SUBJECT: DRAFT REPORT DEVELOPED BY IAEA MISSION ON KRSKO STEAM  
GENERATOR MODIFICATIONS

Advisory Mission To Yugoslavia (7-12 June, 1982)

At the request of the Permanent Mission of Yugoslavia to the IAEA an advisory mission including five persons was sent to Yugoslavia during the period 7-12 June, 1982. The purpose was to discuss steam generator vibration problems at the Krsko nuclear power plant with the licensing authority and plant management and to give advice on associated plant modifications.

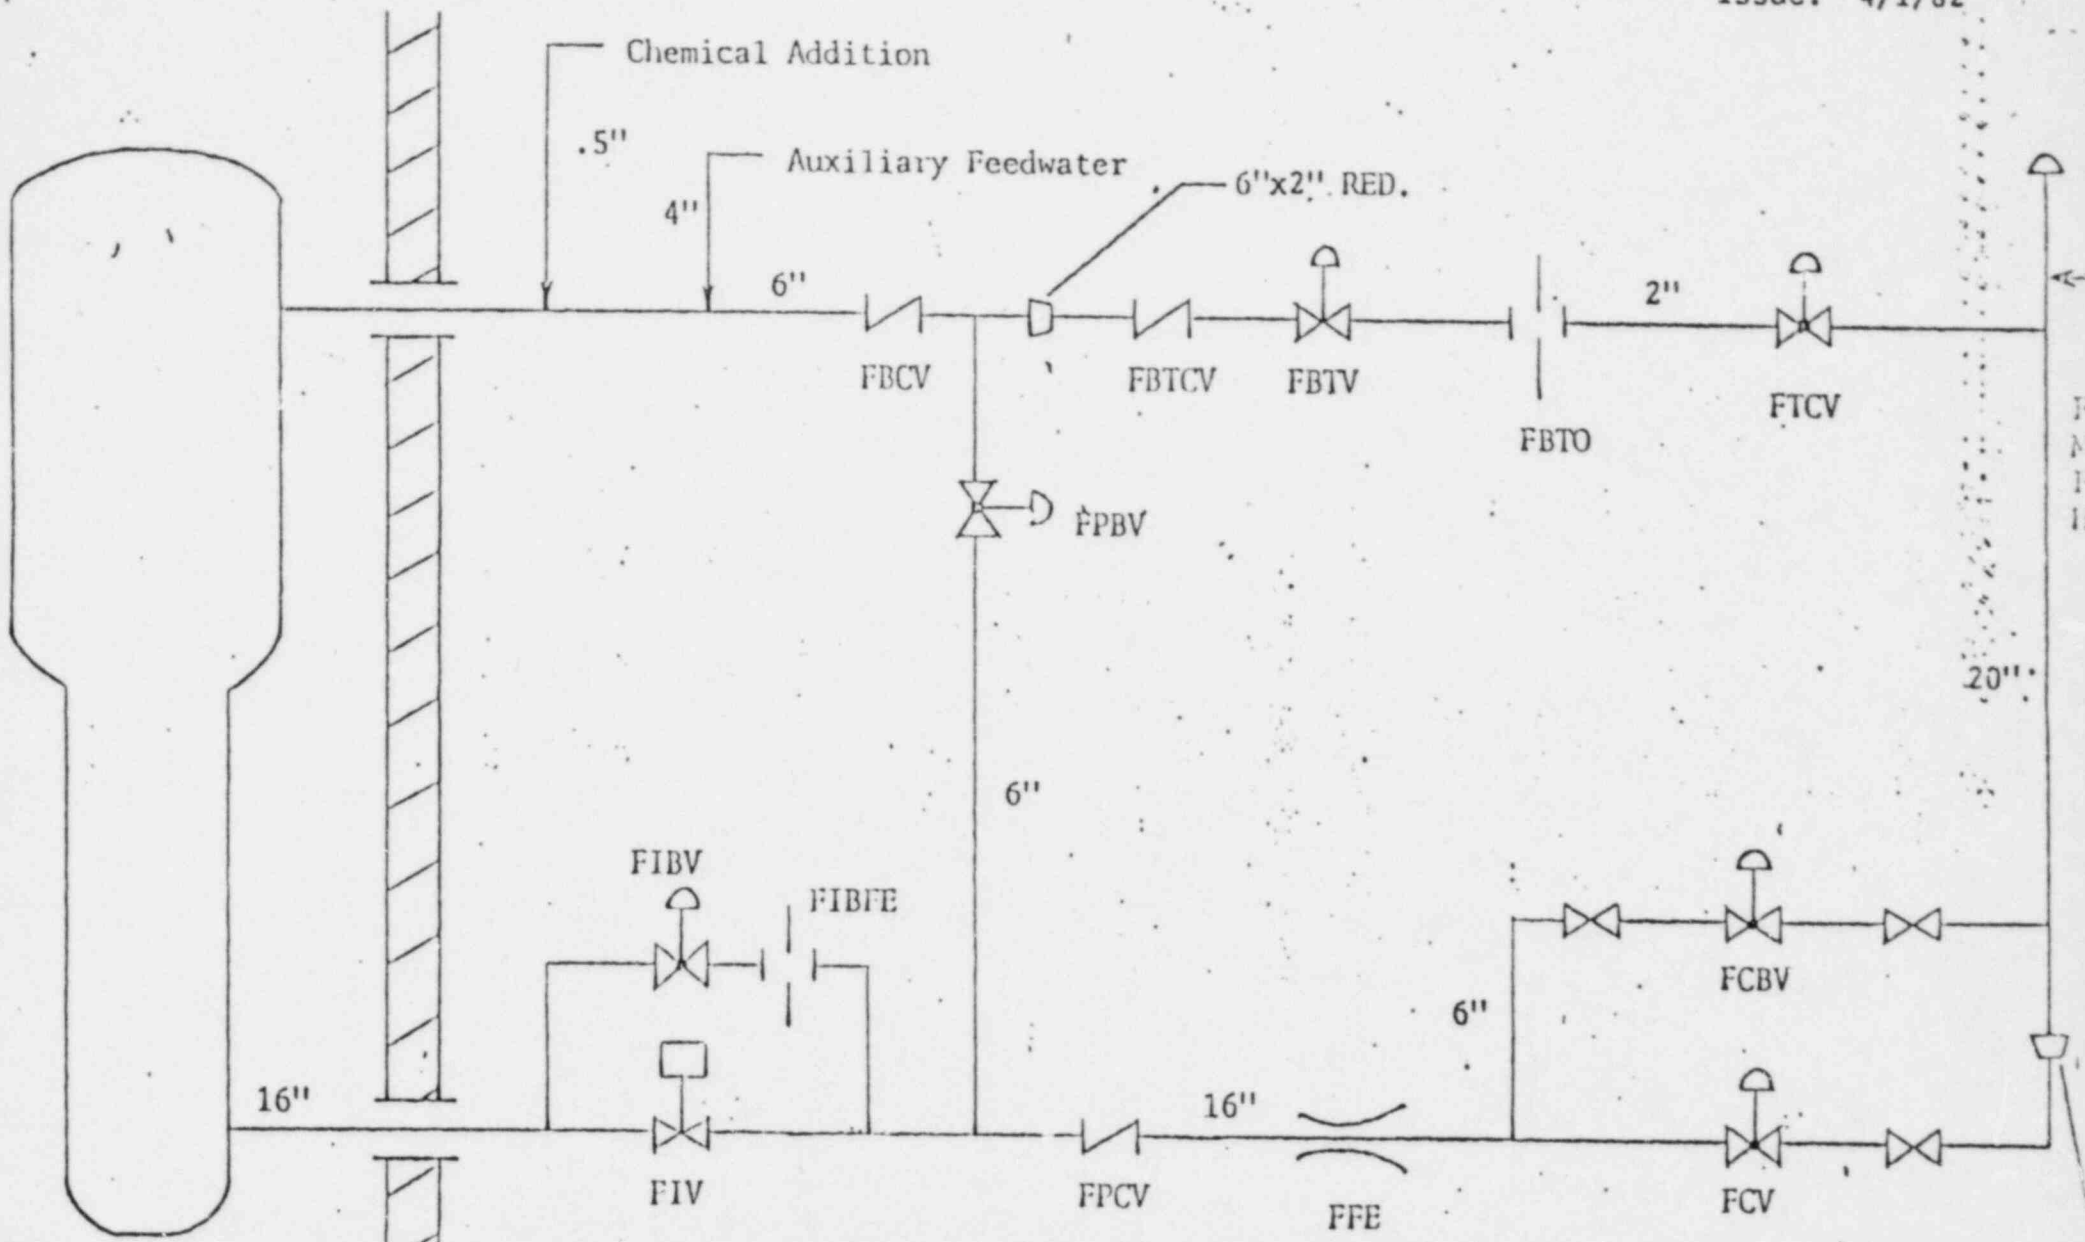
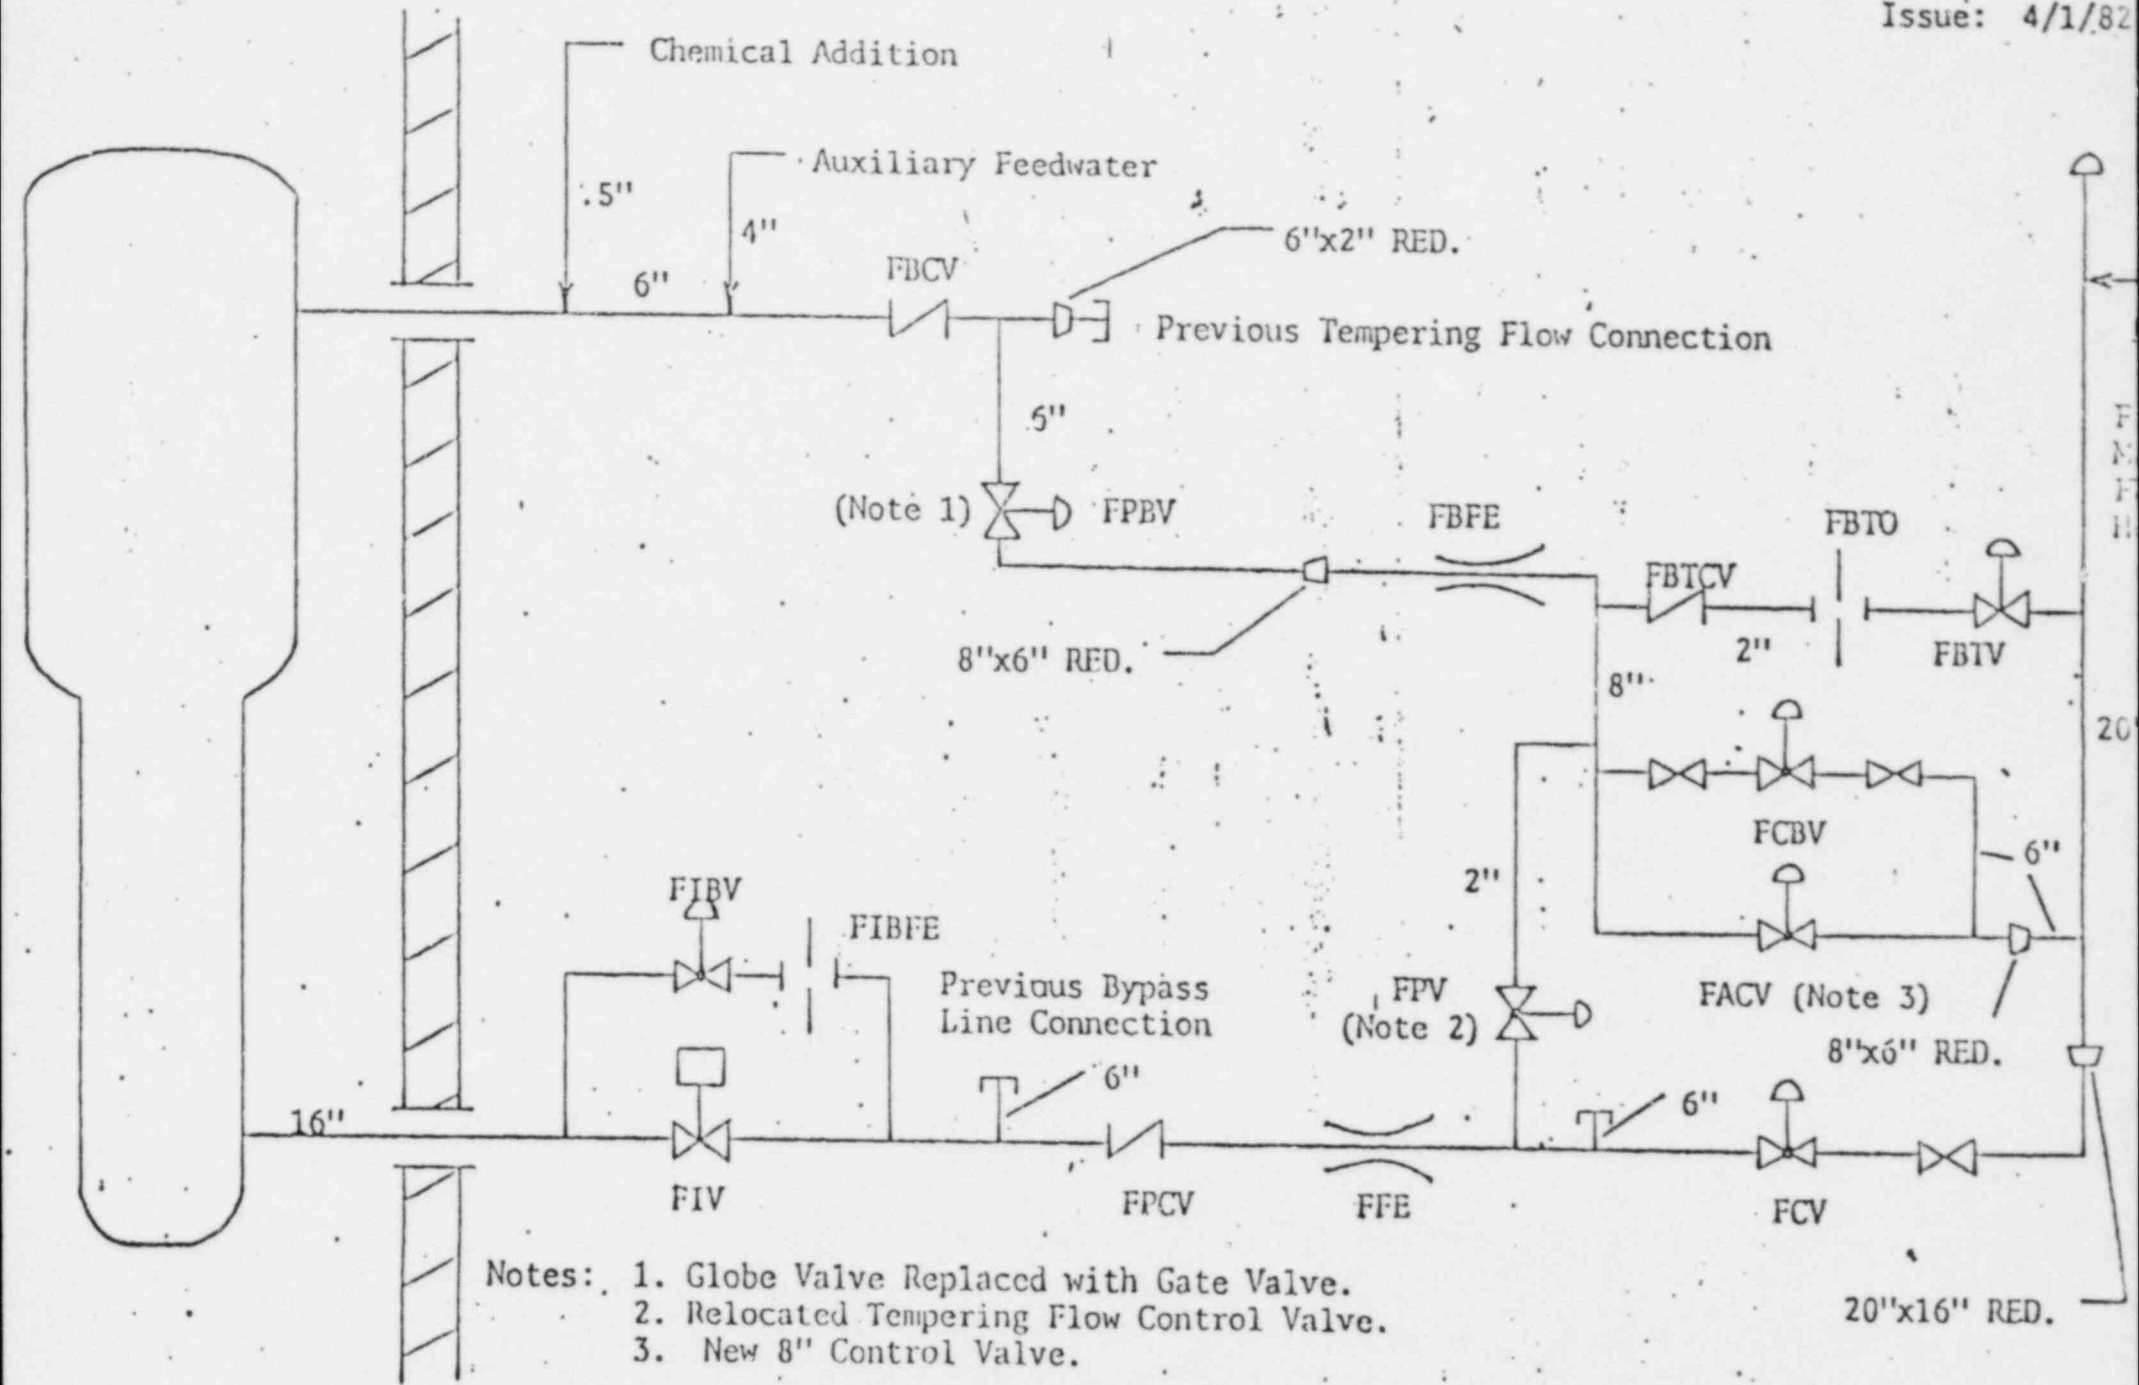
The proposed modification of the feedwater system is extensive. The Mission recommends that the ~~independent design reviews of this modification be completed on a timely basis.~~ The review should include mechanical and thermo-hydraulic aspects as well as those relating to control and protection system modifications.

With regard to the steam generators, the Mission identified the concern of vibration of the intermediate deck plate due to the increased auxiliary nozzle flow injection.

Reduced flow through the preheater section (from 100% to 70% flow) may lead to increased steam formation at the bottom part of the preheater. The Mission was informed that the vendor did not expect any water hammer hazard to develop as a result of increased steam generation. A criterion was quoted under which no net vapour formation should occur in the four first passes of the preheater. This criterion would also be met at the reduced flow operation. However, the basis for this criterion was not fully clarified.

The reduced flow could also result in sludge deposition at steam generator tube-to-baffle plate intersections. Again, the vendor's evaluation showed that sufficient flow velocities are maintained to prevent sludge deposition. However, it is the Mission's opinion that these concerns justify careful monitoring during initial start-up and subsequent plant operation.

Results from model tests in Sweden have shown extremely high and instable flow velocities after the main feedwater restrictor nozzle in the D-3 type steam generator. For this reason, the Mission would recommend that the exchange of this restrictor by a multi-venturi nozzle restrictor should be considered for Krsko as a means to reduce the velocities and to provide a more uniform flow distribution into the downcomer channel. This should ensure a steady flow entrance to the preheater tube-bank.
